CHARTER TOWNSHIP OF VAN BUREN
PLANNING COMMISSION AGENDA
Wednesday, August 24th, 2022 – 5:30 PM
Van Buren Township Hall
46425 Tyler Road

ITEM # 1 **Case 21-021- General Development Company, LLC – Final Site Plan**

TO: Van Buren Township Planning Commission
FROM: Dan Power– Director of Planning and Economic Development
RE: Case 21-021: General Development Company, LLC / Kenworth / CSM Companies, Inc. – Final Site Plan Review
DATE: August 18, 2022

Subject: VBT-21-021; SPR/SLU, Kenworth / CMS / I-94 N. Service Dr.; Site Plan Review #4 (FINAL); Revised Site Plans Dated July 14, 2022.

NFE JOB NO. **M314** SHEET NO. **C-2a**

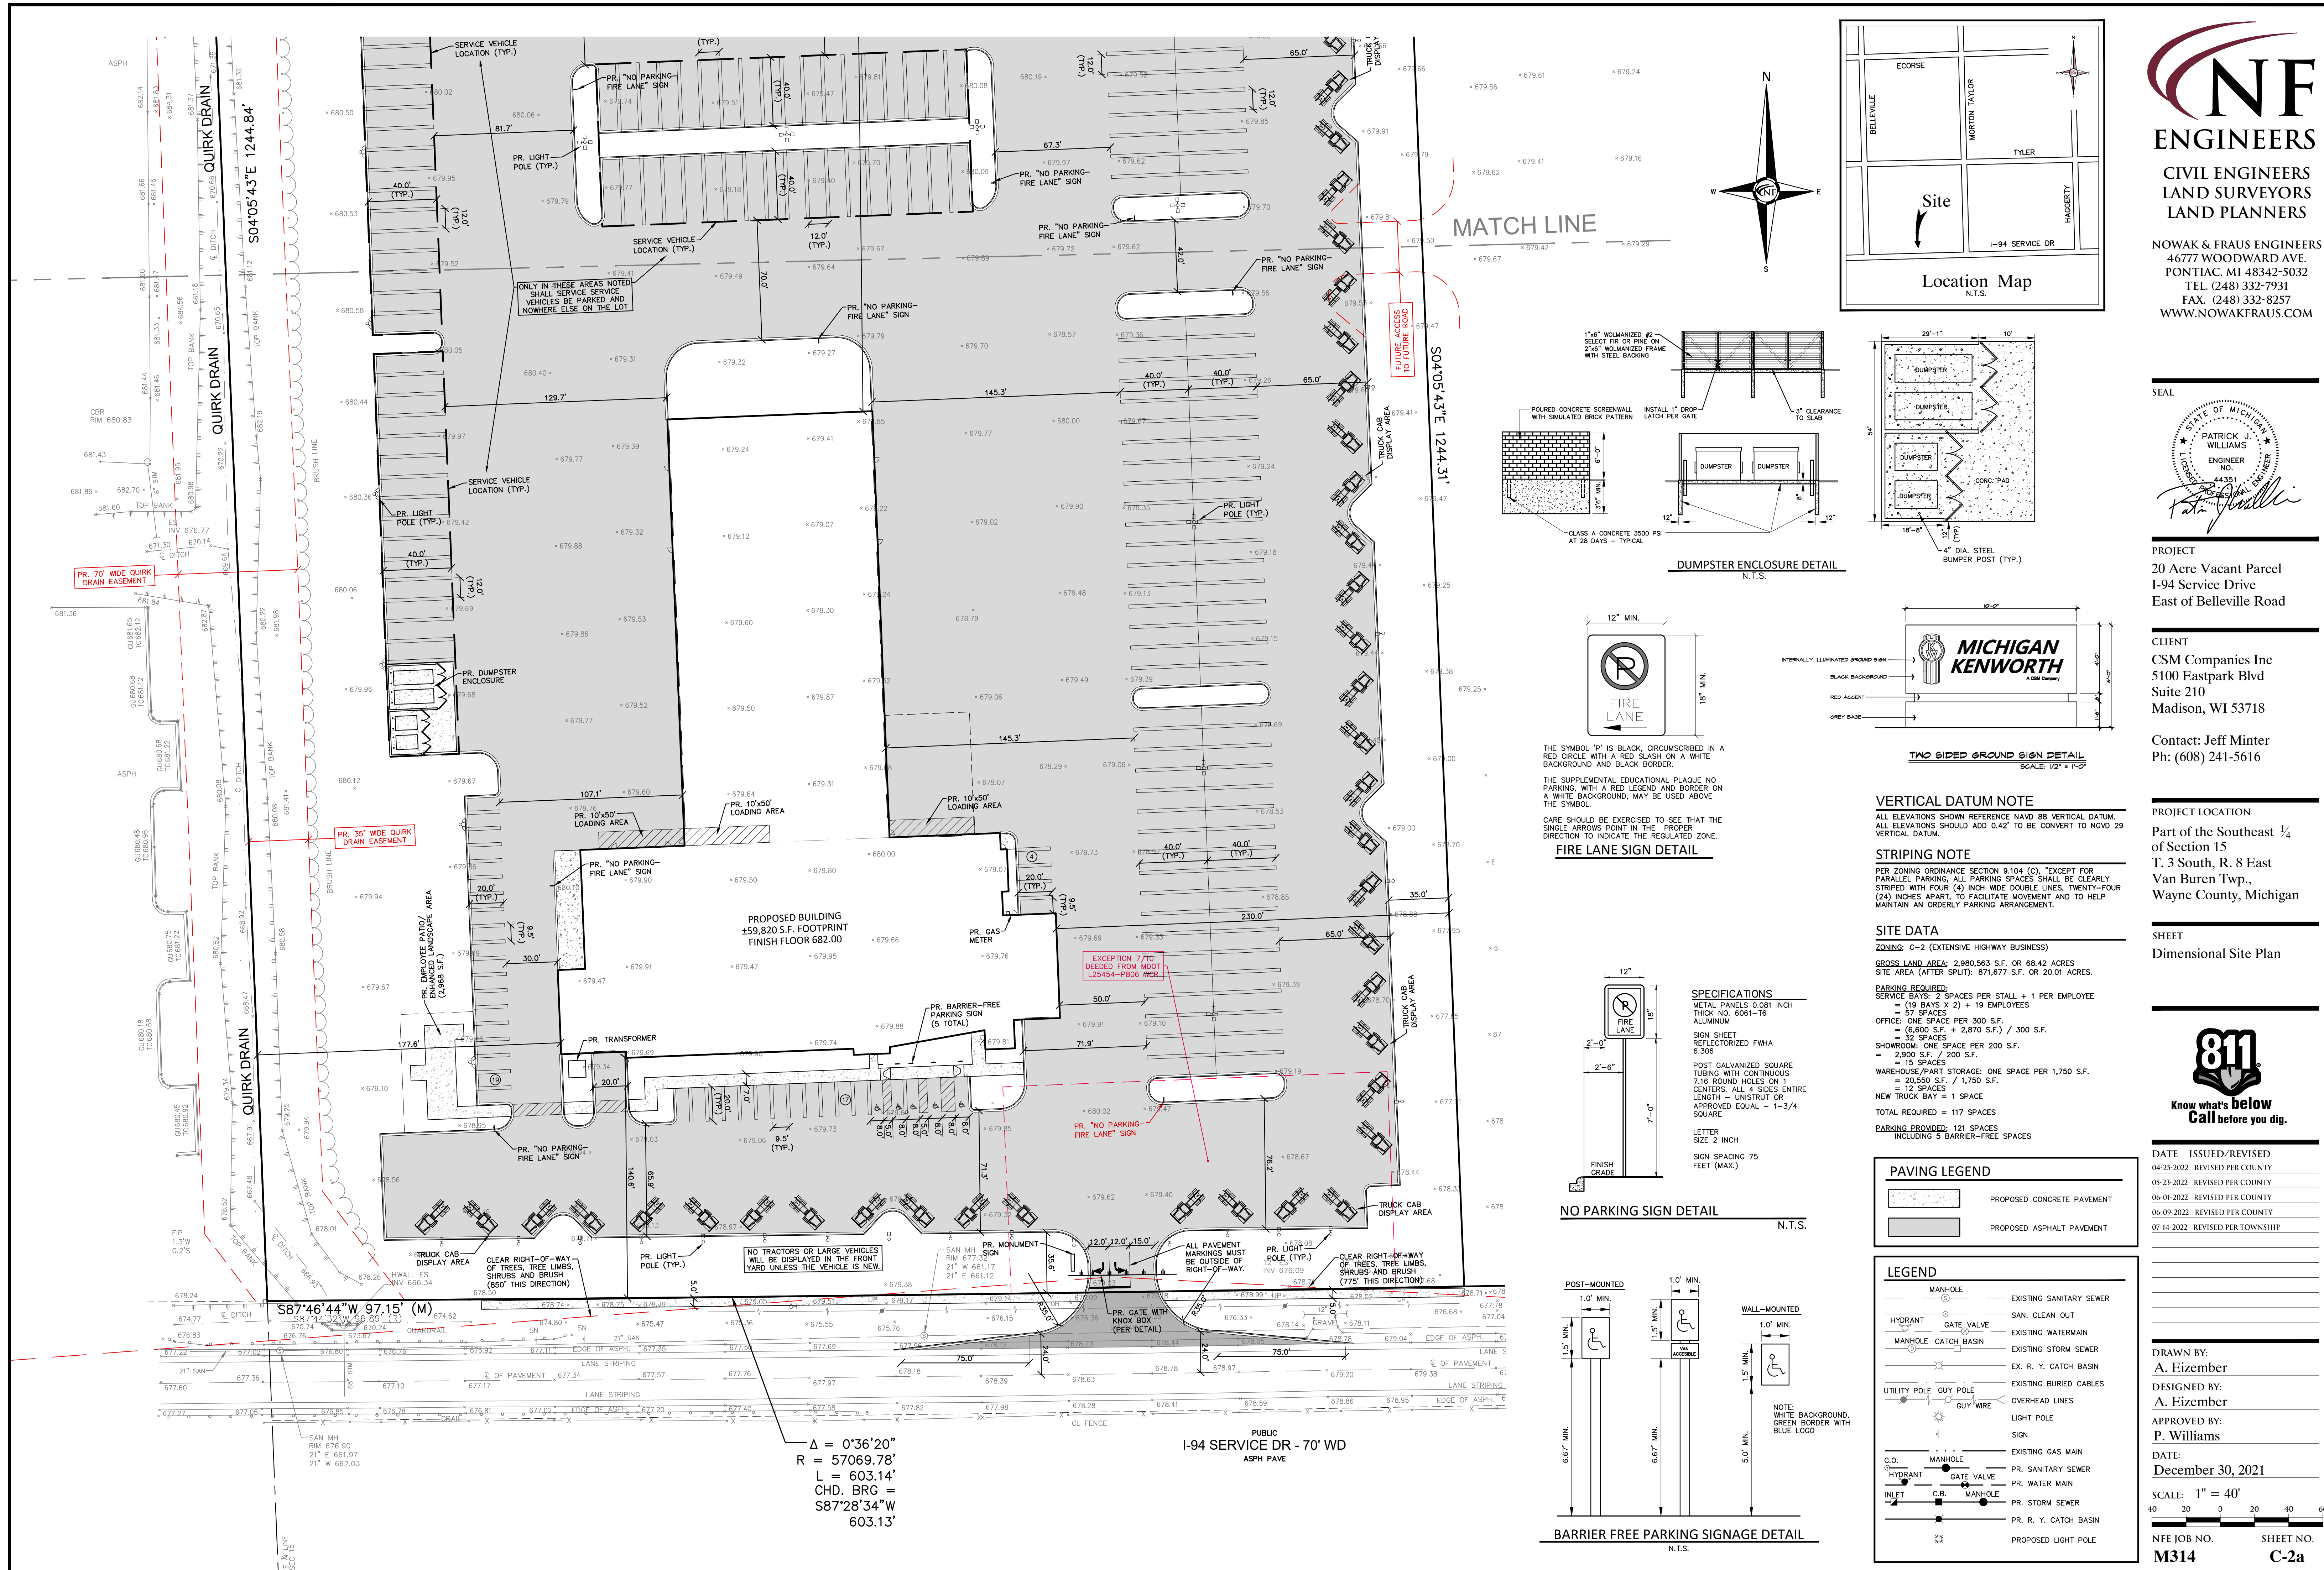
12. **Revision of monument sign design to include 24" tall masonry base as required by Ordinance.** This condition can be met. A detail of the sign has been provided on Sheet C-2a; however, the detail does not identify the monument base material, only colors. Further it appears the base is only 18" with a 6" narrower pedestal on top which does not meet the ordinance's definition. The monument sign is defined by the ordinance as having a solid supporting base equal to or greater than the width of the sign face constructed of a decorative and durable material (e.g., masonry), and shall have no separations between the sign face and the base. The supporting base shall have a minimum 24-inch vertical height and shall be constructed of masonry to match the building.

13. Additional Changes. With the final site plan submittal, the applicant has proposed a 6' tall security gate at the entrance which was not included on the preliminary plans. The gate is shown on sheets C-2a and sheet C-2b. The Zoning Ordinance does not permit fencing or gates in the front yard that exceed a height of 2.5 feet. The gate height must be reduced based on the limits of Section 7.205(B)(1)(b) of the Zoning Ordinance.
